Form C-103
 Revised July 18, 2013

WELL API NO. 30-015-27095
5. Indicate Type of Lease STATE <input checked="" type="checkbox"/> FEE <input type="checkbox"/>
6. State Oil & Gas Lease No.
7. Lease Name or Unit Agreement Name POKER LAKE 32 STATE
8. Well Number #003
9. OGRID Number 16696
10. Pool name or Wildcat [53815] SAND DUNES;DELAWARE, WEST

13. Describe proposed or completed operations. (Clearly state all pertinent details, and give pertinent dates, including estimated date of starting any proposed work). SEE RULE 19.15.7.14 NMAC. For Multiple Completions: Attach wellbore diagram of proposed completion or recompletion.

OXY PROPOSES TO PLUG THE SUBJECT WELL. A PA PREP RIG MIGHT BE USED TO PULL EQUIPMENT SO A PA PREP PROCEDURE IS ATTACHED. THE CURRENT WELLBORE, PROPOSED WELLBORE, AND PA PROCEDURE ARE ALSO ATTACHED.

NOTICE OF INTENT TO PLUG AND ABANDON**10/16/2024****POKER LAKE 32 STATE 003****30-015-27095-0000****PE: Travis Brashear****PLUGGING PROCEDURE:**

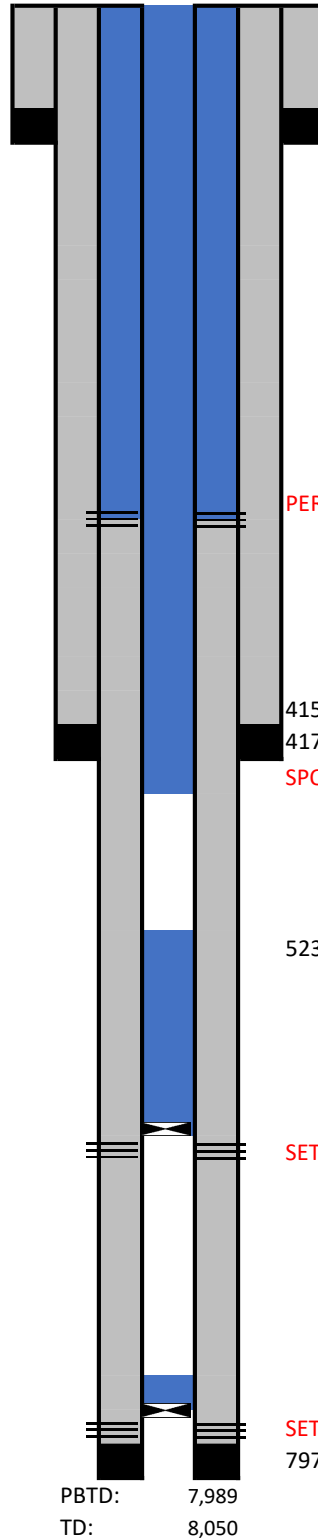
PERF AND SQUEEZE 658 SXS 2,790' - Surface. WOC AND TAG.

SPOT 143 SXS CMT 4,205' - 2,800'. WOC AND TAG.

SET CIBP @6,232'. SPOT 107 SXS CMT 6,232' - 5,180'. WOC AND TAG.

SET CIBP @7,754'. SPOT 25 SXS CLASS H CMT 7,754' - 7,560'. WOC AND TAG.
